PRESERVATION —	Certificate of Appro waukee Historic Preservation Commission/200 E. We	priateness ells Street/Milwaukee, WI 53202/phone 414-286-5712/fax 414-2	86-3004
Property	2544 N. 47TH ST.	47 th Street Bu	ingalows
Description of work	molding, rafters, and tails will be repar	on-elastomeric paint, including dormers, trim, a ired and painted. Repairs are to be in kind with tyems. Replace roofing with BP Canada Evere	n natural,
	Replace gutters with new half-round or K-type gutters. Replace downspouts with modern code-compliant downspouts that are disconnected from the combined sewer system where practical. Downspouts shall be painted or colored to match trim, including extension pieces on the front lawn, if any. Extensions onto the front lawn may not be white.		
	4/4/2019 PTS ID	•

In accordance with the provisions of Section 320-21 (11) and (12) of the Milwaukee Code of Ordinances, the Milwaukee Historic Preservation Commission has issued a certificate of appropriateness for the work listed above. The work was found to be consistent with preservation guidelines. The following conditions apply to this certificate of appropriateness:

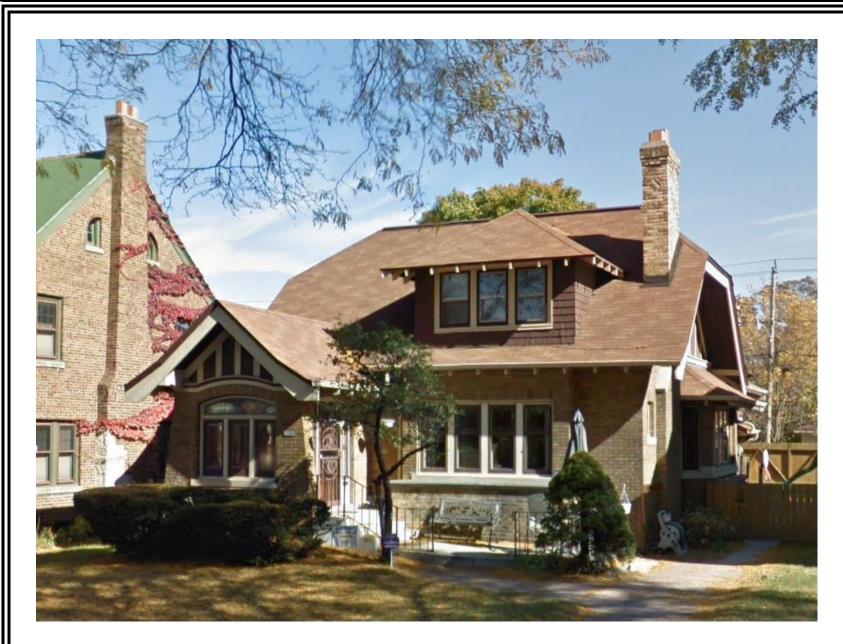
Typical downspout disconnection. The horizontal extender piece must be painted to match the house or be an earth tone that will blend with the lawn.
